Introduction

This chapter of the FEIR for the Union City Intermodal Station Passenger Rail Project (Proposed Project) contains Master Responses intended to consolidate in one discussion the responses to key issues on a single subject raised in multiple comments. Responses to issues that fall outside of the Master Responses are addressed in the FEIR Chapters 3 and 4. Revisions made to the DEIR pursuant to Master Responses are included in the FEIR Chapter 4. Where an individual response to a comment is covered by a Master Response, this is also noted in the FEIR Chapters 3 and 4.

PD-3: Redesigned Shinn Connection

Figure 2-1
Redesigned Shinn Connection

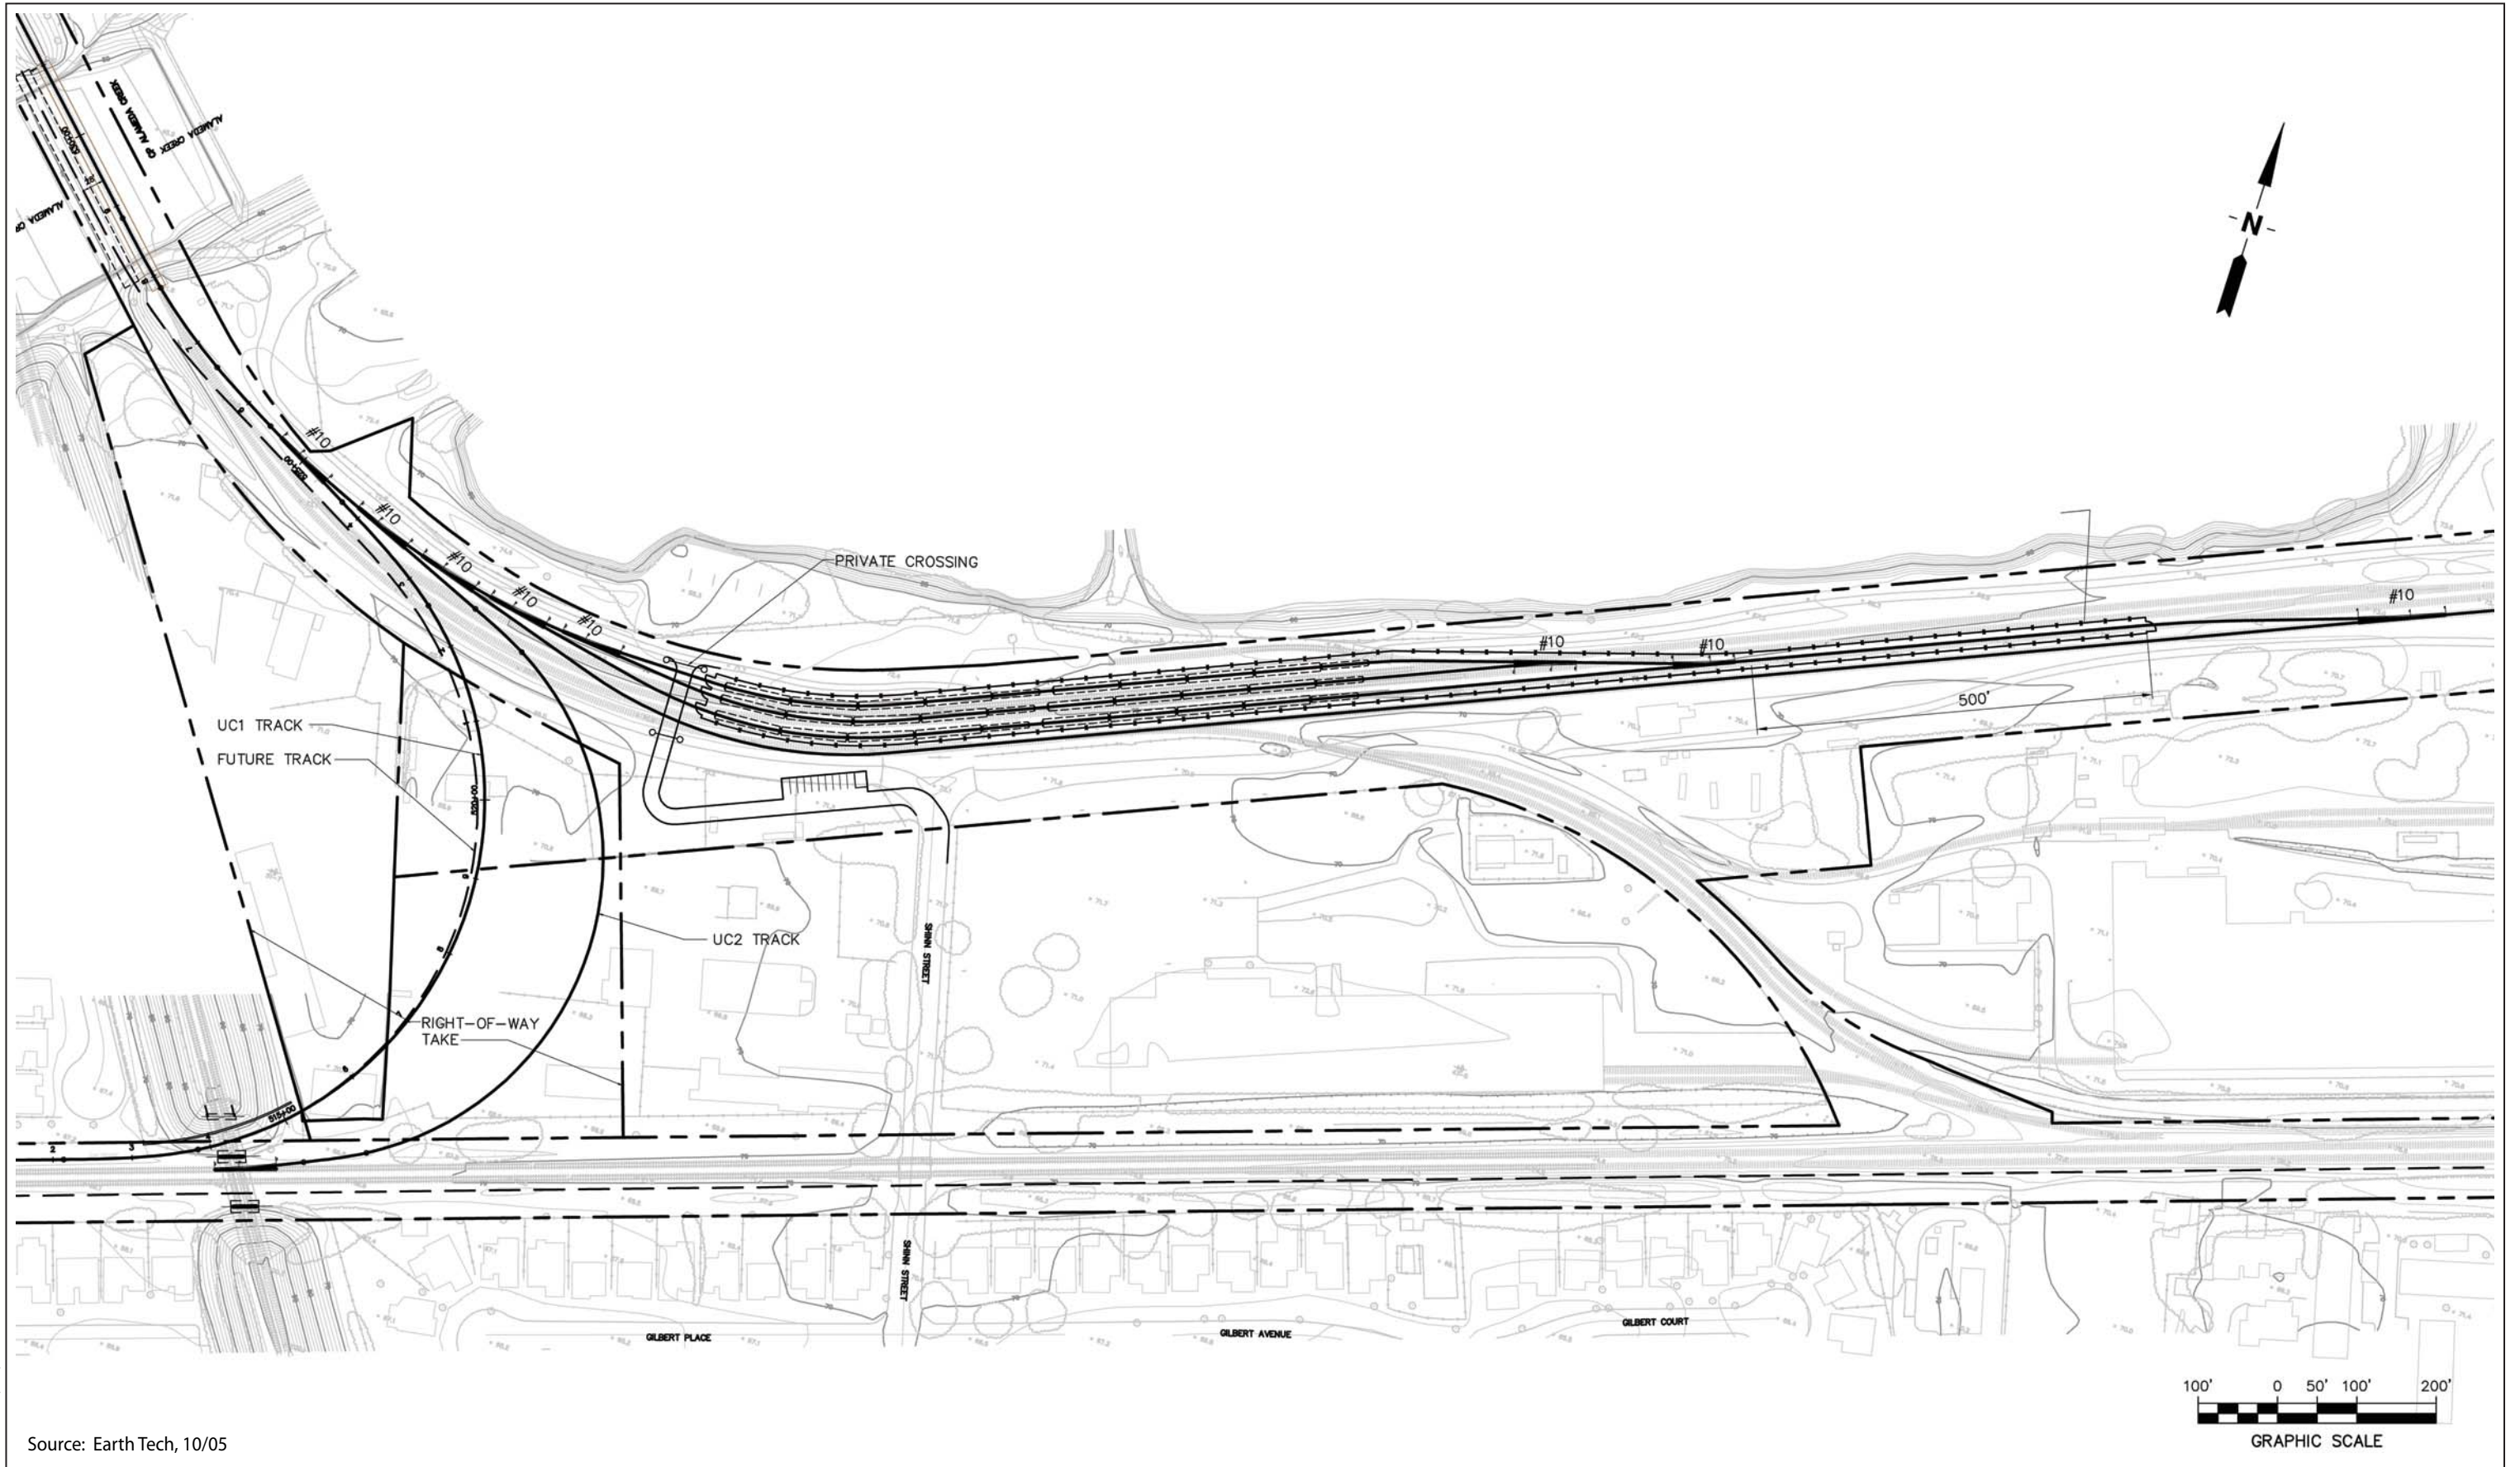
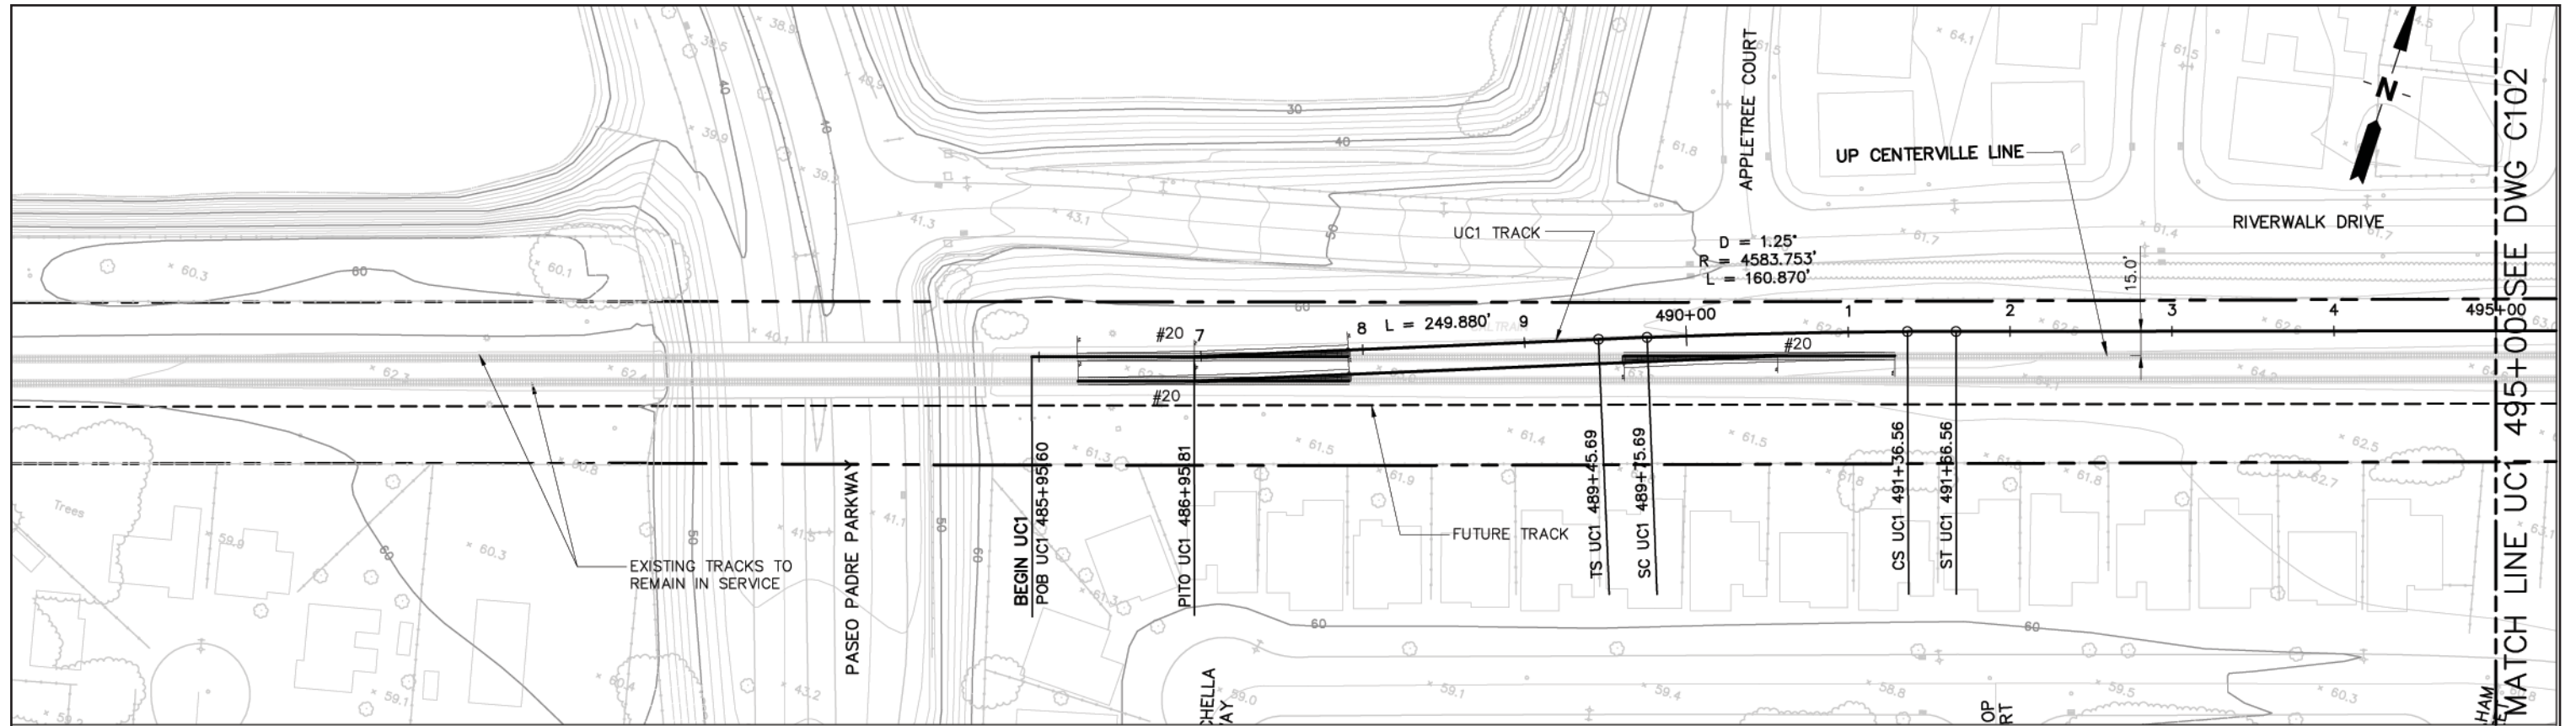
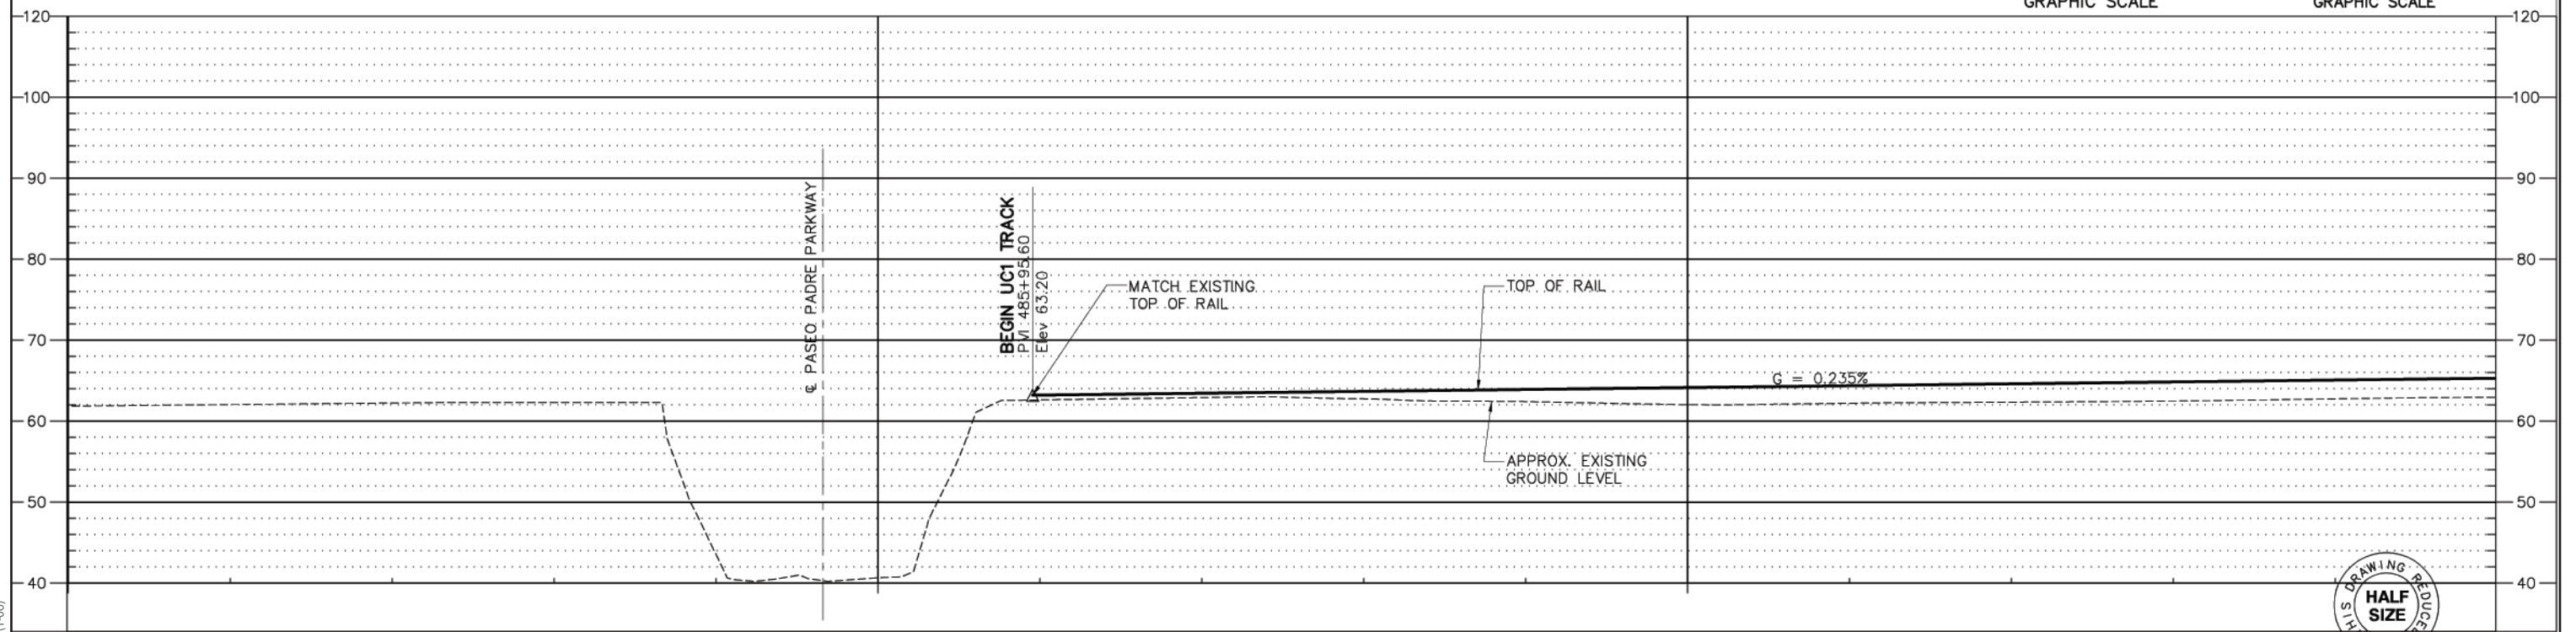
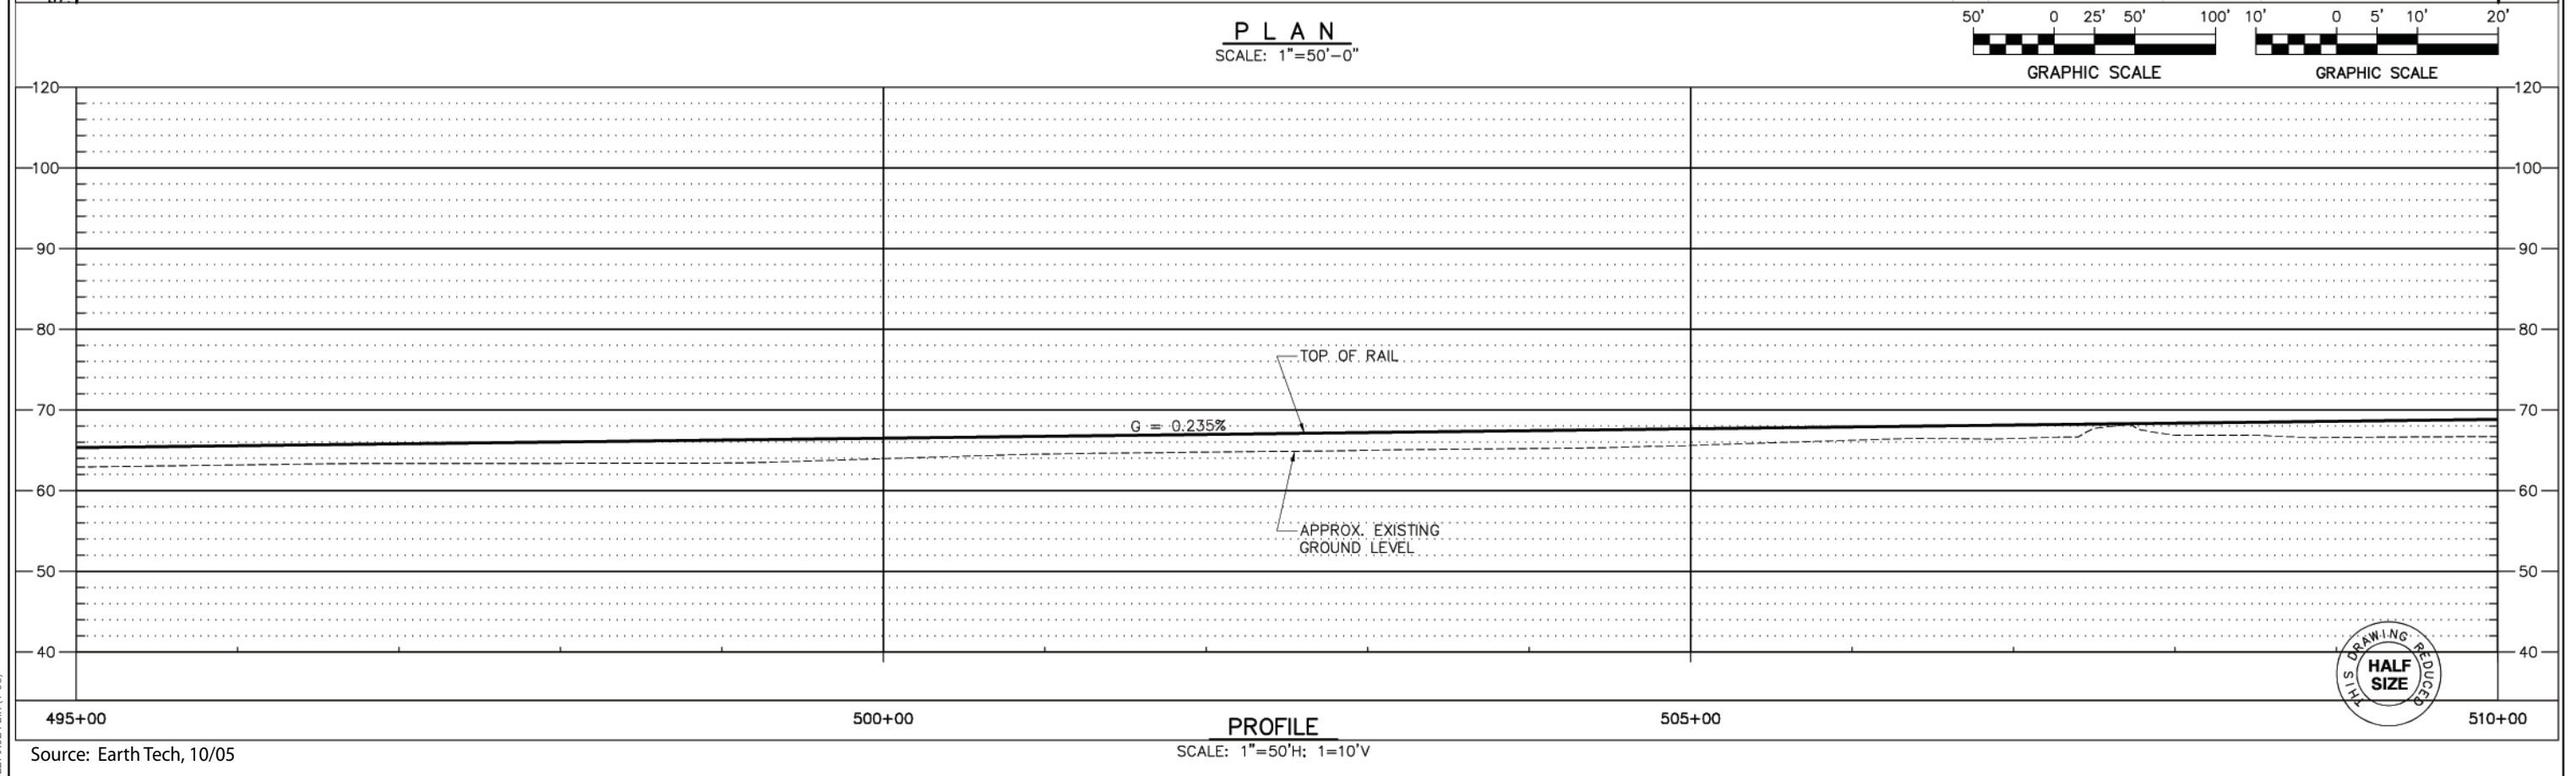
Several comments expressed concern about the effectiveness of movable point or spring rail frogs in mitigating noise and vibration impacts associated with turnouts. Some comments also suggested that the turnout adjacent to the Riverwalk neighborhood be relocated farther to the west, as was suggested as possible mitigation in the DEIR. In response to those comments, the City has revised the project to relocate the turnout adjacent to the Riverwalk neighborhood to the west, past the western end of the neighborhood and to

Several comments on the DEIR expressed concern about the effect of the Shinn connection on the Riverwalk neighborhood. Specifically, the comments addressed the need to acquire property, remove landscaping, and replace the fence at the end of Riverwalk Drive; the aesthetic impacts of the underpass of the BART tracks; air quality, noise, and vibration impacts, and construction noise and lighting. The City has developed a revised design for the Shinn connection that incorporates the recommendations made in comment by individuals and local agencies. The redesigned Shinn connection moves the new section of curved track slightly farther to the east and adds a second set of tracks to improve train movement (see Figures 2-1 through 2-7).

The revised design eliminates the need to acquire property from the Riverwalk neighborhood and moves the new tracks for the Shinn connection farther away from residences. The northern/western tracks join the Centerville Line west of the Riverwalk subdivision and incorporate moveable point frog technology into the design of the turnout where the tracks connect. The southern/eastern set of tracks would connect to the Centerville Line underneath the BART overpass (see Figure 2-5). The connection would incorporate moveable point frog technology for the turnout where the tracks connect. In the DEIR, the Shinn connection joined the Centerville Line adjacent to the Riverwalk subdivision and the moveable point frog was not part of the Proposed Project design, but was recommended as mitigation for noise and vibration impacts. The moveable point frog eliminates noise and vibration impacts associated with the turnout, therefore, DEIR Mitigation Measure NV-3, Relocate Turnouts or Install Spring Rail “Frogs,” is no longer necessary.

The northern tracks pass under the BART tracks farther to the east than the design in the DEIR and slightly farther from the home at the eastern terminus of Riverwalk Drive. This alignment would require considerably less modification of

the BART overpass of the Centerville Line than the design in the DEIR and would not require acquisition of any right of way from the Riverwalk Homeowners Association. Additionally, the existing sound wall and landscaping at the southeastern boundary of the Riverwalk subdivision would not be affected by the revised Shinn connection and would therefore not need to be replaced.

Both sets of tracks in the redesigned Shinn connection would have a tighter curve than the design in the DEIR and would therefore have a higher likelihood of generating noise from wheel squeal. With the redesigned Shinn connection, the BART berm and the existing sound wall on the southeast boundary of the Riverwalk subdivision would shield the neighborhood from wheel squeal and, therefore, DEIR Mitigation Measure NV-1, Replace Existing Sound Wall in the Riverwalk Subdivision along the New Shinn Connection, is no longer required to mitigate noise from wheel squeal. Please see PRDEIR for a detailed discussion of noise impacts and mitigation measures related to the redesigned Shinn connection.
